FIELD CHANGE ORDER Number: CIBCI-I002

Applicability: The L0118 Rev B* module should be installed on all CI750, CI780, CIBCI, & HSCxx nodes used in VAXclusters of 6 (six) or more CI/HSC nodes connected to a common SC008 Star Coupler. L0118s should replace all L0100 Rev D* link modules; L0100 Rev E* can coexist with L0118s except in greater than 16 node environment.

Problem/Symptom: Clusters of 6 or more CI/HSC nodes on SC008 may exhibit CI-PATH NO_RSP or NAK, ARB-TIMEOUTS, and VC-CLOSURE. L0118 (& L0100 Rev E*) corrects adjacent-node collision & arb problems. * FIX DETAILS ON PAGE 2. *

SET L0100-E1 COMPATIBILITY JUMPER AS FOLLOWS:

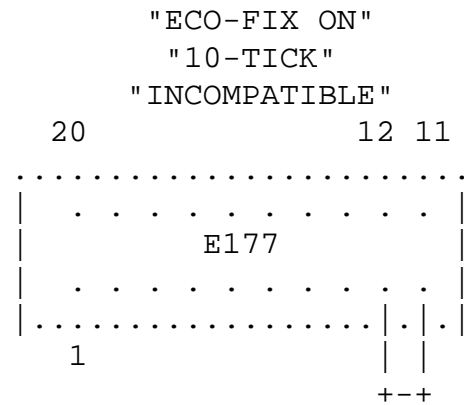
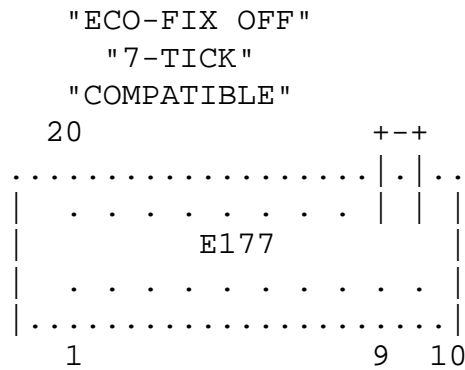
-
- o 7/10-TICK COMPAT. MODE SET BY 1 JUMPER @ E177 stake-pins.
 - "7-TICK COMPAT.-MODE": jumper E177-11 to E177-12
 - "10-TICK INCOMPAT.-MODE": jumper E177-9 to E177-10
- o NO CLUSTER-SIZE OR FUNCTION-MODE JUMPERS/SWITCHES.
- o L0100-E1 QUICK-CHECK (PART-REVISION VERIFY):
 - ECO wires at E177-13 and E177-9.
 - STAKE-PINS (for jumper) @ E177-9,10,11,12.
 - ETCH REV-C: P/N "50-14430C-0" marking.
